Form 3160-5
(June 2019)

SUNDRY NOTICES AND REPORTS ON WELLS
Do not use this form for proposals to drill or to re-enter an abandoned well. Use Form 3160-3 (APD) for such proposals.

8. Well Name and No. PRETTY GOOD 20 FED COM/706H

EOG respectfully requests an amendment to our approved APD for this well to reflect the following changes:

Revised Wellbore

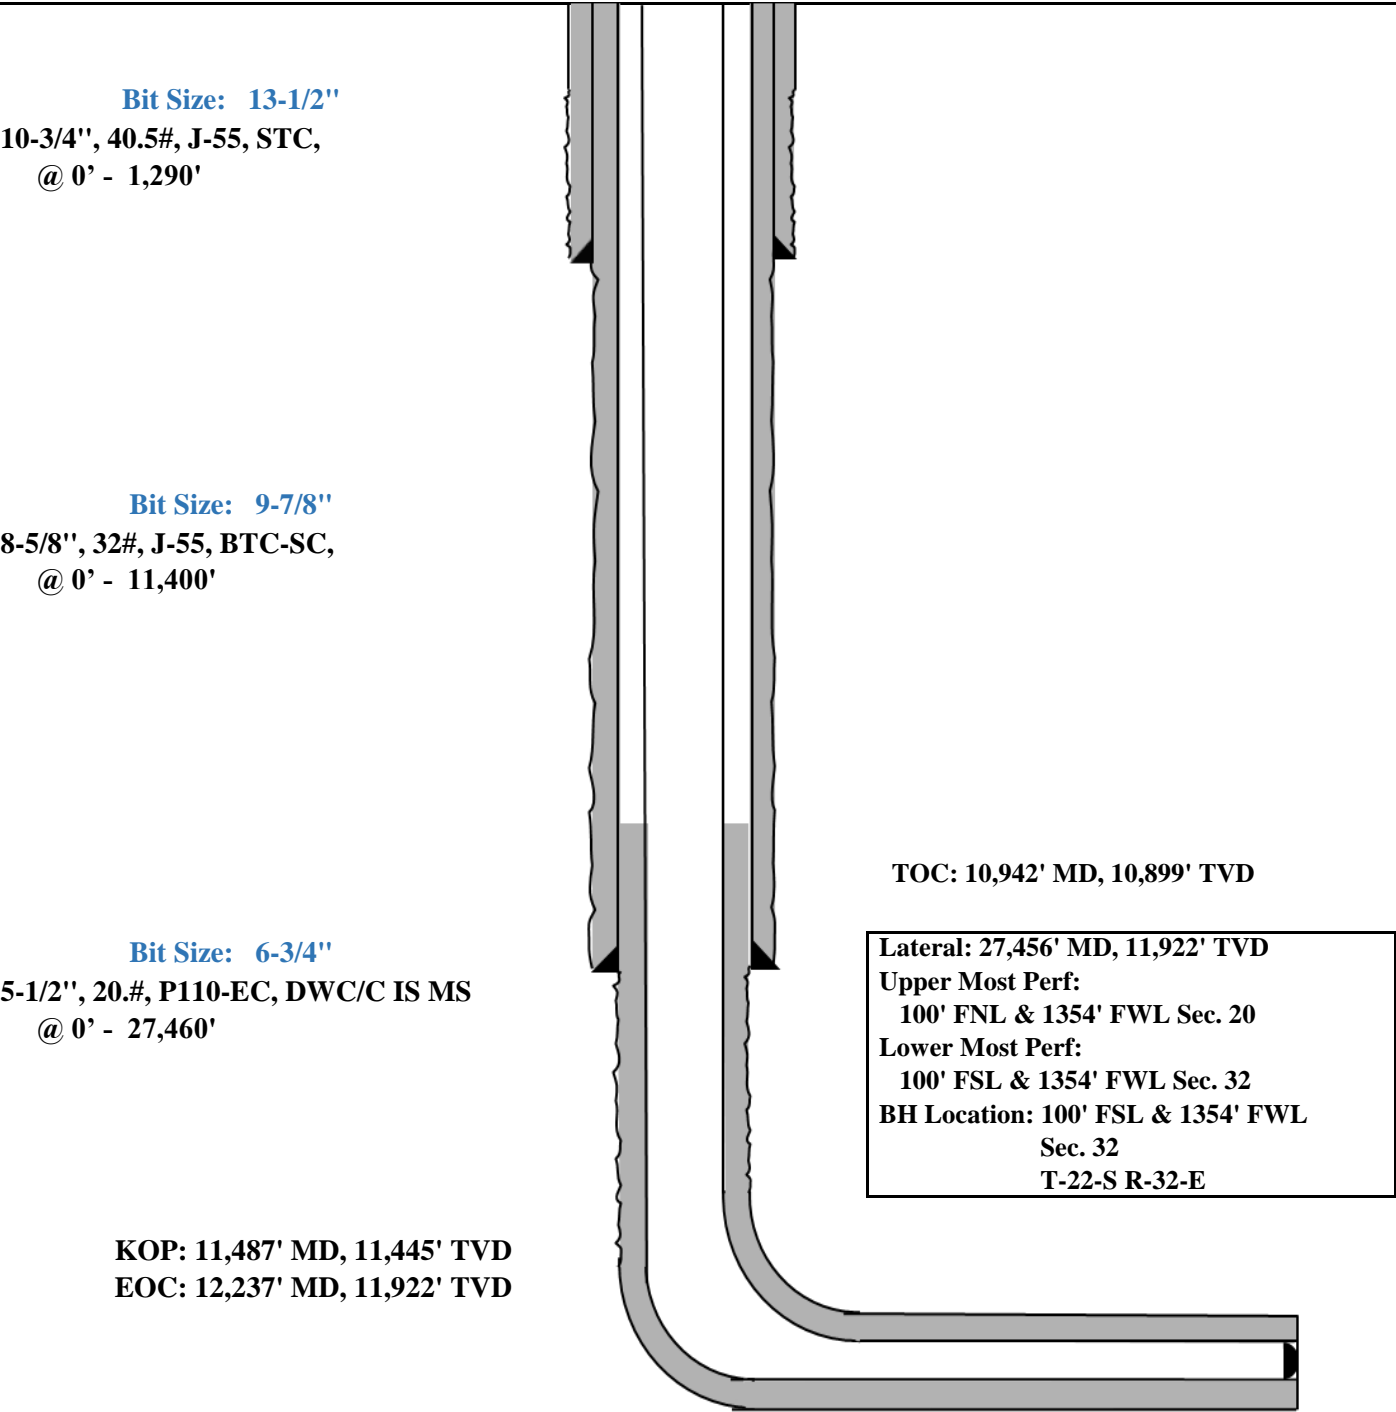
Change name from Pretty Good 20 Fed Com 706H to Pretty Good 20 Fed Com 608H.

Change BHL from T-22-S, R-32-E, Sec 32, 100' FSL, 2330' FWL, LEA Co., NM, to T-22-S, R-32-E, Sec 32, 100' FSL, 1354' FWL, LEA Co., N.M.

Change target formation to Third Bone Spring Carbonate.
